Westinghouse Electric Company
Nuclear Power Plants
P.O. Box 355
Pittsburgh, Pennsylvania 15230-0355
USA

SUBJECT: Transmittal of Responses to AP1000 DSER Open Items

DCP/NRC1617
Docket No. 52-006

SUBJECT: Transmittal of Westinghouse Proprietary Class 2 Documents Related to
AP1000 Design Certification Review Draft Safety Evaluation Report (DSER)
Open Item Response

Figure 15.6.5.4C-13

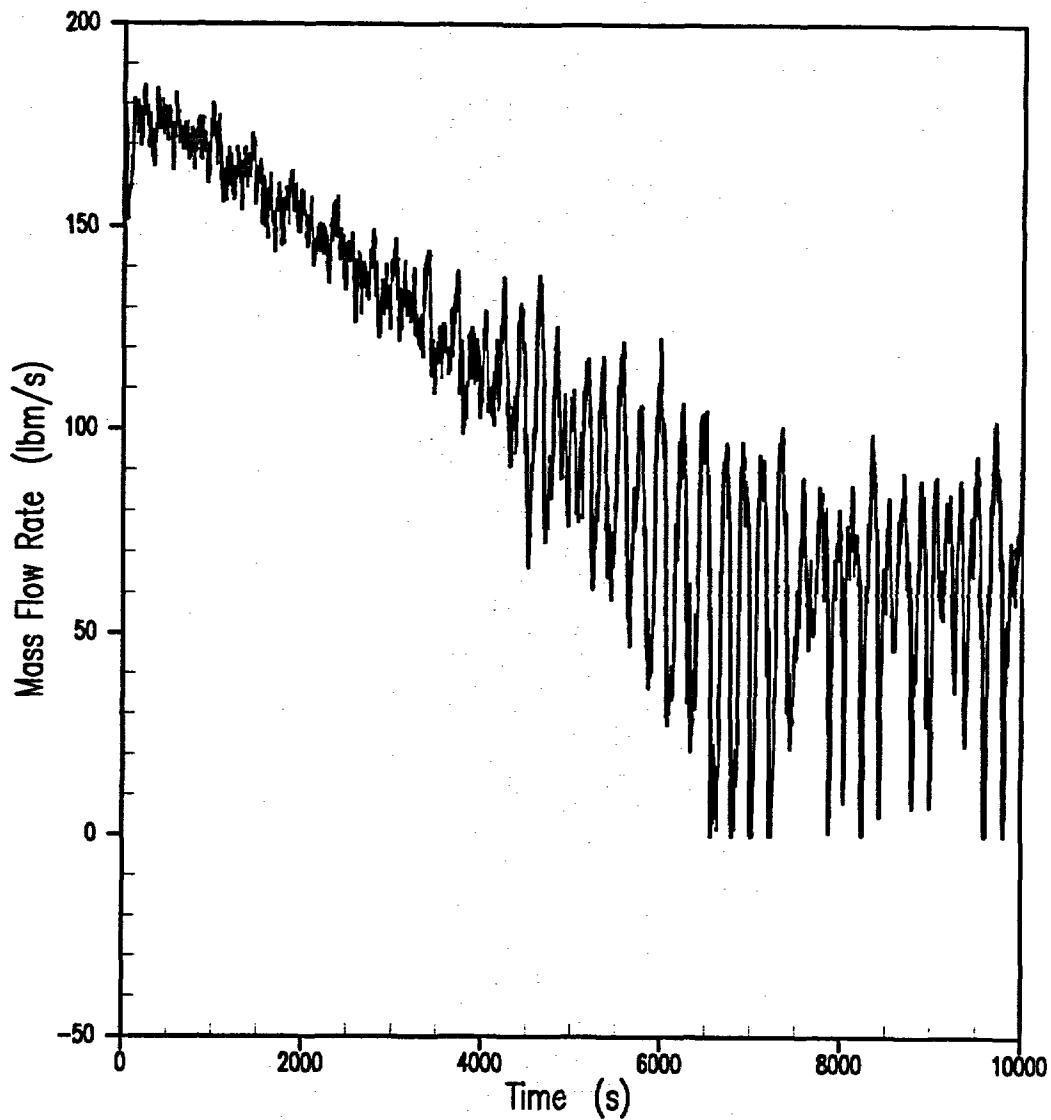
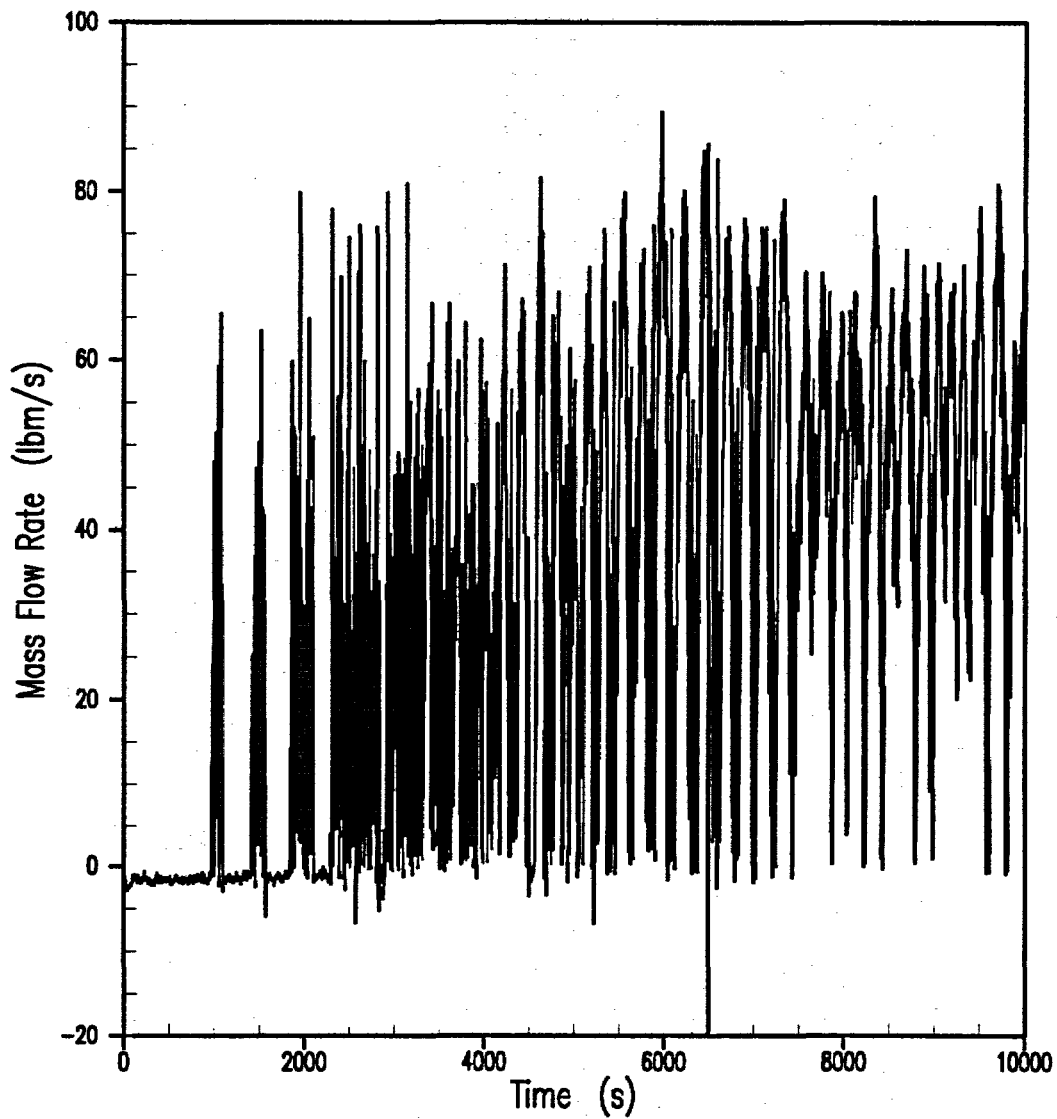
calculated across the reactor vessel, and injection rates through the DVI lines into the vessel are presented in Figures 15.6.5.4C-13 and -14. Figure 15.6.5.4C-13-14 shows the flow is outward through the broken DVI line at the start of the long-term cooling period, and it increases to a maximum average value of about 5296 lbm/s after the compartment water level has increased above the nozzle elevation to permit liquid injection into the reactor vessel. In contrast, the intact DVI line flow falls from 1780 lbm/s with a full IRWST to about 8065 lbm/s flow from the containment at the end of the calculation. The recirculation core liquid throughput is more than adequate to preclude any boron buildup on the fuel.

Figure 15.6.5.4C-15

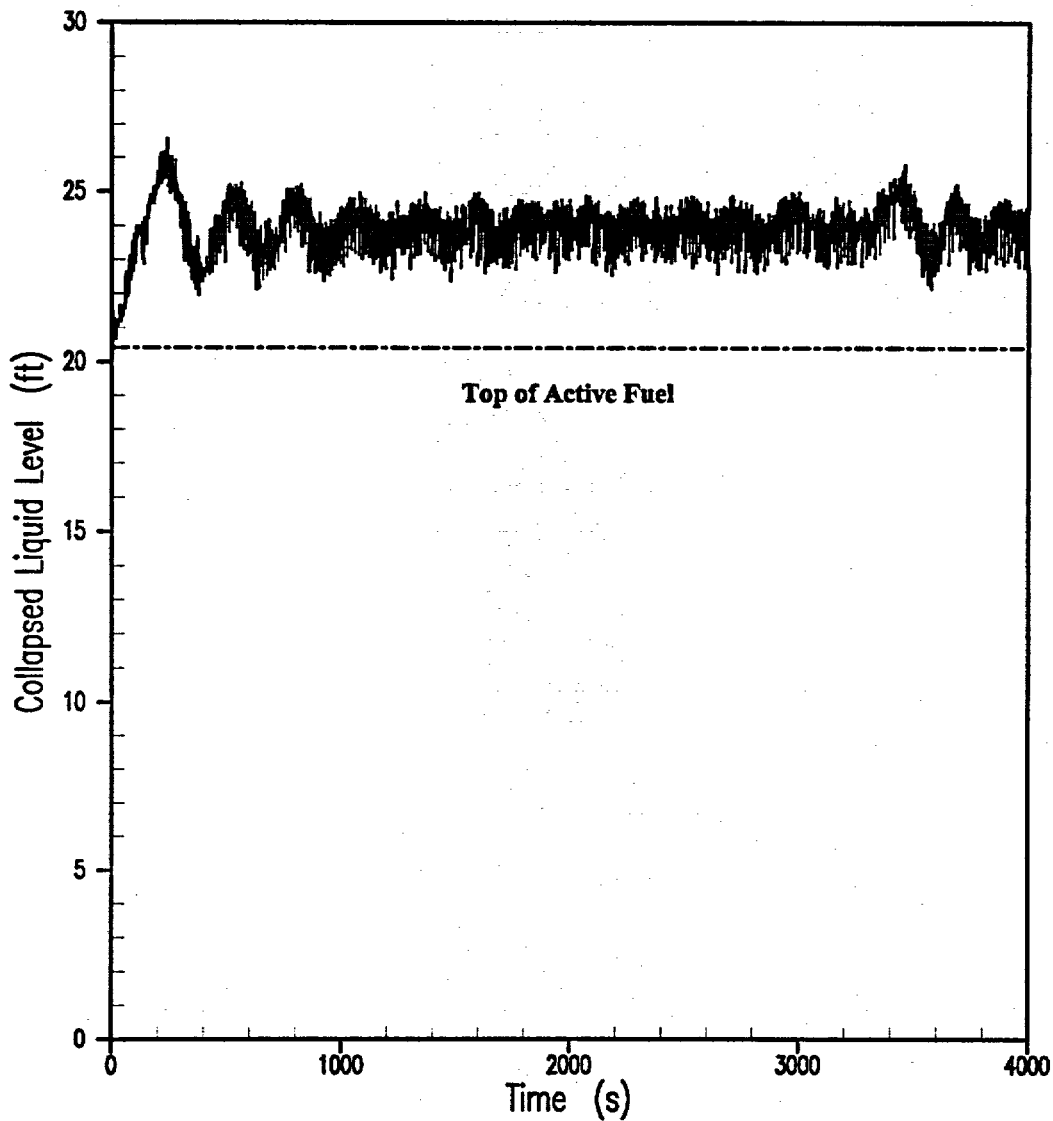
The downcomer collapsed liquid level (Figure 15.6.5.4C-15) is almost constant during the transient at about 254 feet, just below the lower lip of the DEDVI line nozzles. Pressure spikes produced by boiling in the core can cause the mass flow of the DVI flow rates shown in Figures 15.6.5.4C-27 and -28 into the vessel to stop momentarily, but the injection flow is quickly reestablished.

Figure 15.6.5.4C-16

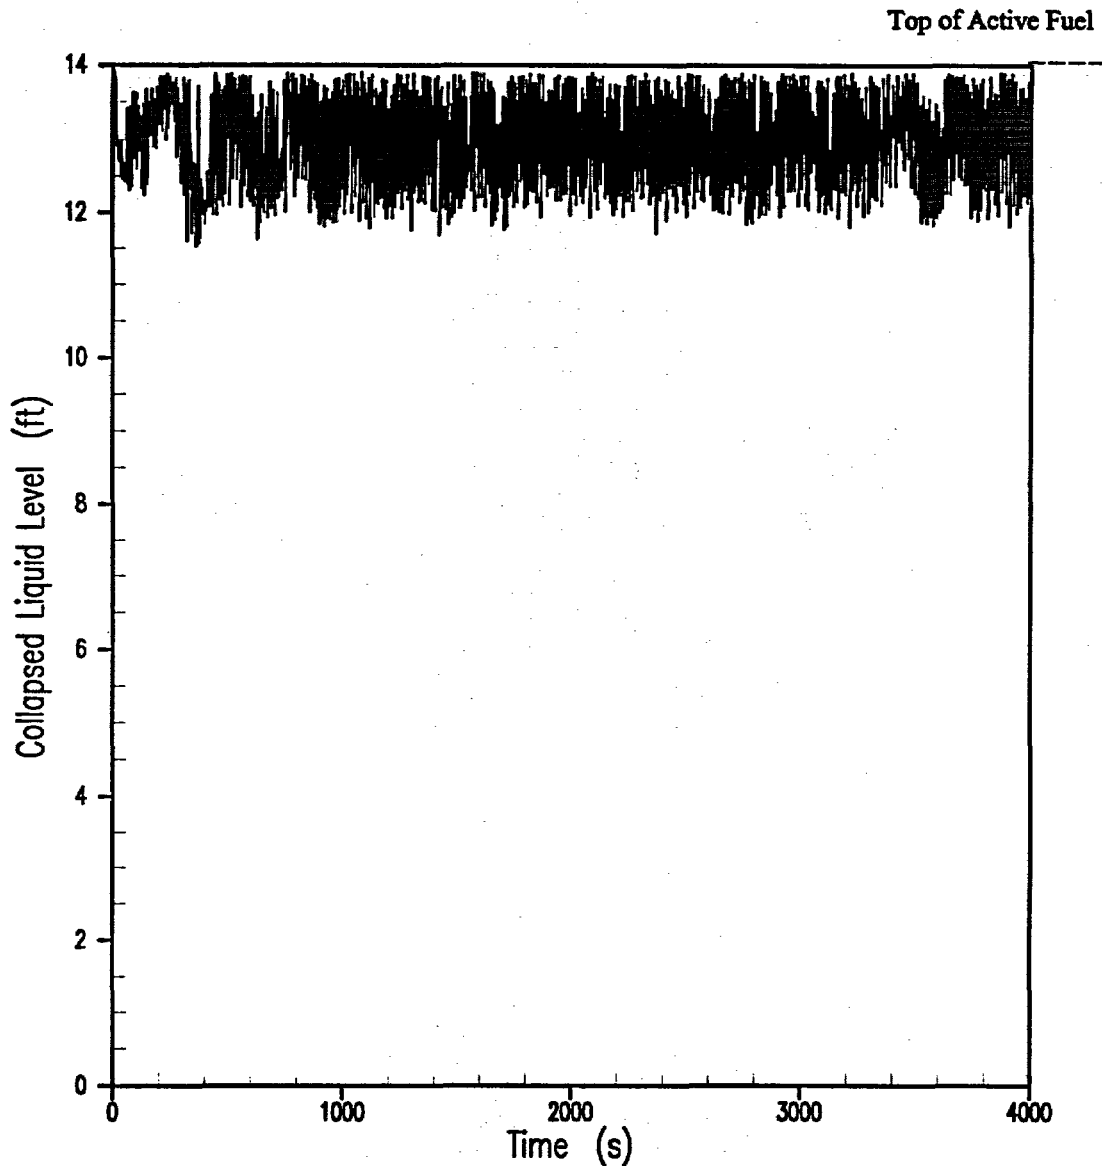
Boiling in the core produces steam and a two-phase mixture, which flows out of the core into the upper plenum. The core is 14 feet high, and the core collapsed liquid level (Figure 15.6.5.4C-16) maintains a mean level close to the top of the core. The boiling process causes pressure variations, which in turn, cause variations in the core collapsed level and the flow rates of liquid and vapor out of the top of the core. In the WCOBRA/TRAC modeling analysis, the core is divided into two axial levels, each 7 feet long and idealized as described in Reference 24. The void fraction in the top level cell is shown in Figure 15.6.5.4C-17 for the core hot assembly, and while Figure 15.6.5.4C-18 shows the small void fraction that exists at the bottom level one cell further down in the hot assembly. The PCT does not rise appreciably above the saturation temperature (Figure 15.6.5.4C.3-26) at the top of the hot rod. The flow through the core and out of the reactor coolant system is more than sufficient to provide adequate flushing

Figure 15.6.5.4C-22

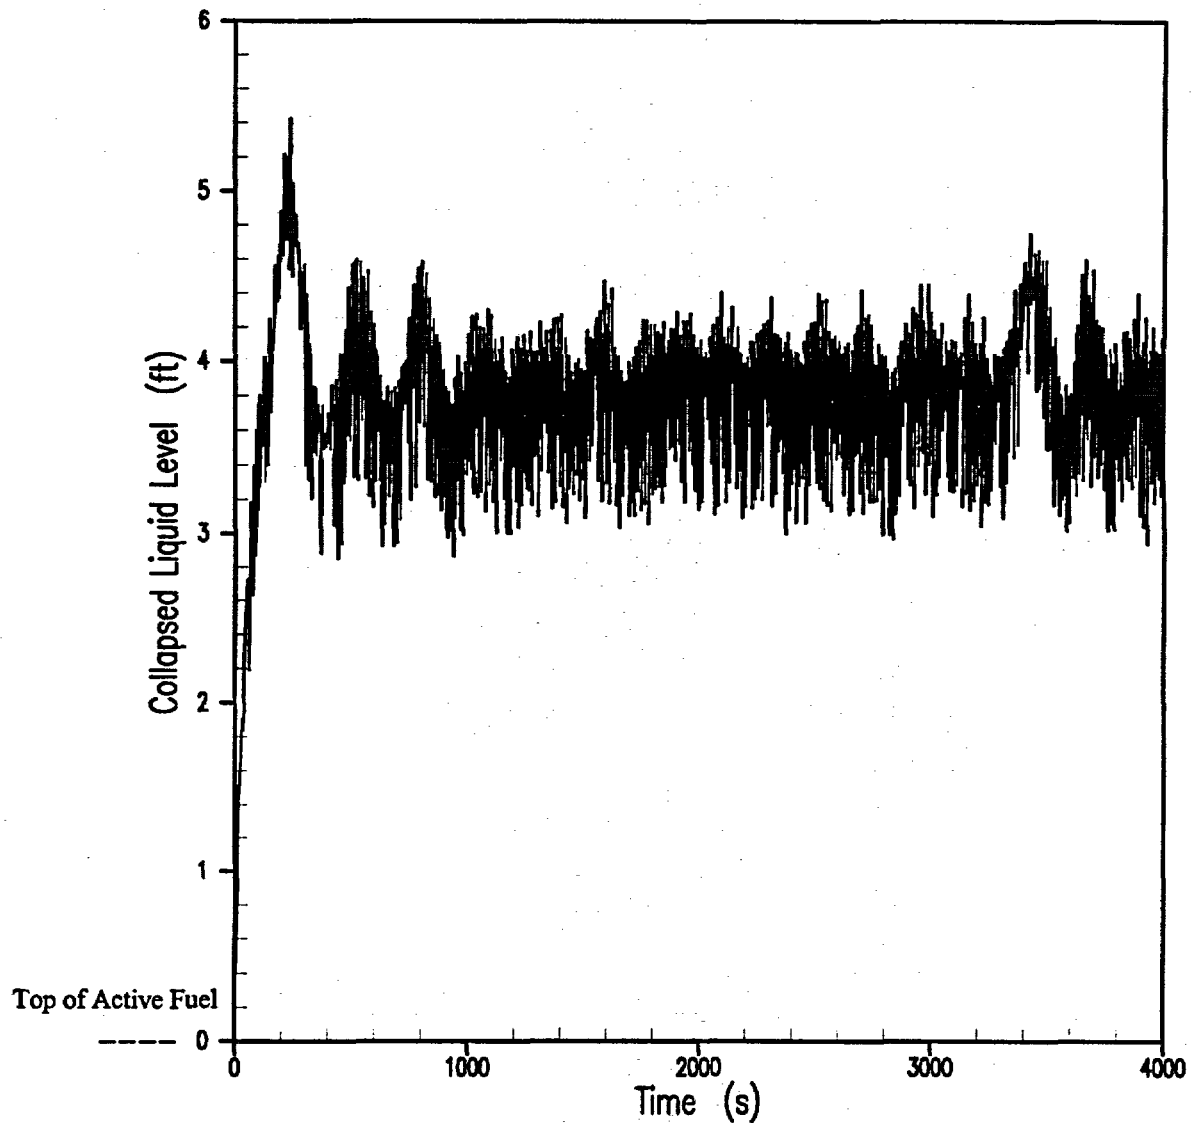
to preclude concentration of the boric acid solution. Liquid collects above the upper core plate in the upper plenum, where the average collapsed liquid level is about 4-63.6 feet (Figure 15.6.5.4C-22). There is no significant flow through the cold legs into either the broken or the intact loops, and there is no significant quantity of liquid residing in any of the cold legs.

Figure 15.6.5.4C-25

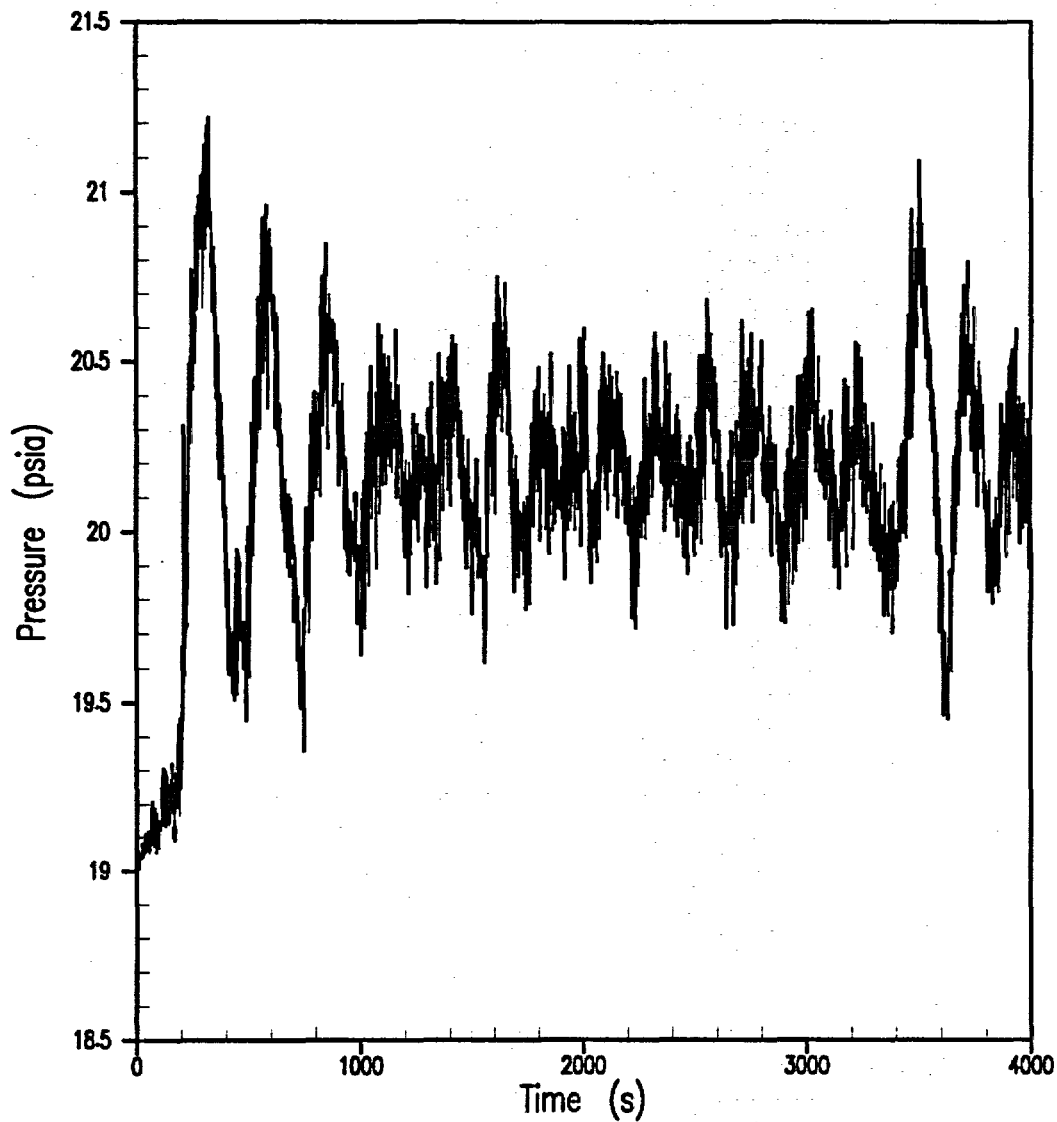
The pressure in the upper plenum is shown in Figure 15.6.5.4C-25. The upper plenum pressurization, which occurs periodically, is due to the ADS Stage 4 water discharge. The collapsed liquid level in the hot leg of the pressurizer loop varies between 0-01.0 feet to 2-02.2 feet, as shown in Figure 15.6.5.4C-19. Injection rates through the DVI lines into the vessel are presented in Figures 15.6.5.4C-27 and -28.

Figure 15.6.5.4C-26

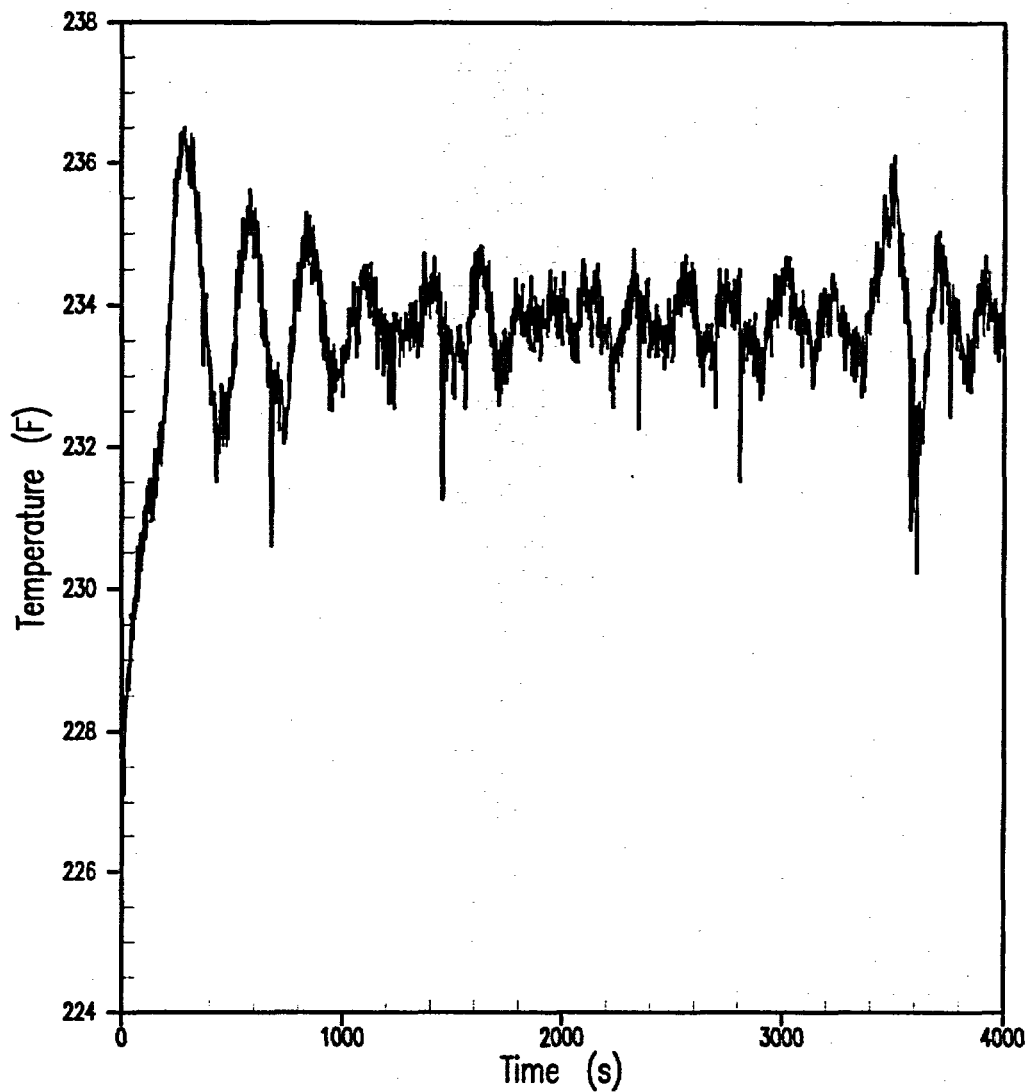
PCT of the Hot Rod Hot Rod Cladding Temperature Near Top of Core
(Wall-to-Wall Floodup Case)
